Inspection Report

Mine Name: Energy Queen (formerly Hecla Shaft)
Operator Name: Energy Fuels Resources

Permit number: M0370043
Inspection Date: March 13, 2008
Time: About 1:30-2:00 PM

Photo 8. A pile of waste material near the gate to the lined pond.

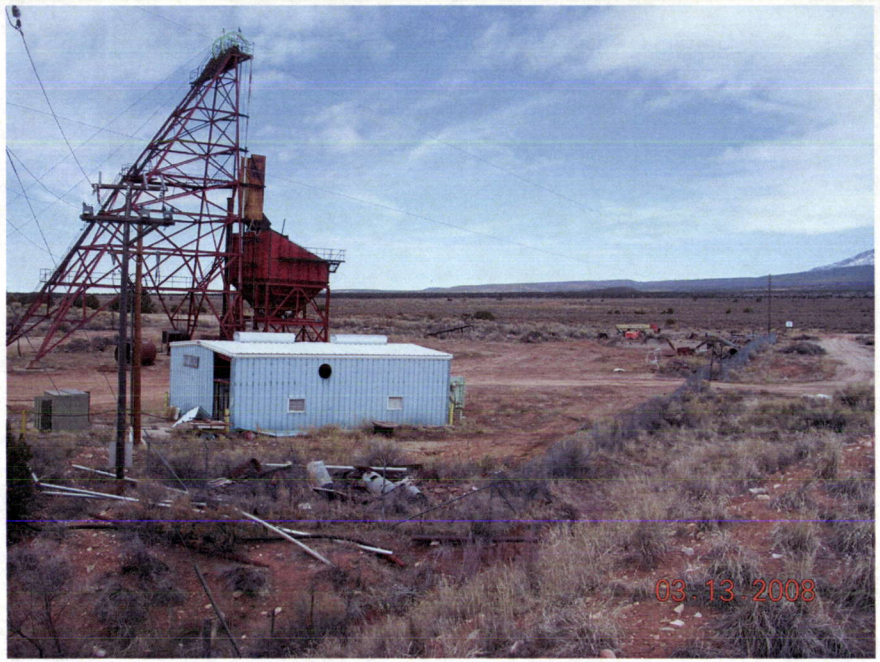
12. Other
Near the gate by the lined pond, there is a pile of waste material (Photo 8), and this waste is not included in the disturbed area shown on a map submitted in 2005. It *is* included in the disturbed areas on earlier maps.

The map of the disturbed area needs to be updated to include the waste disposal area on the northeast side of the site.
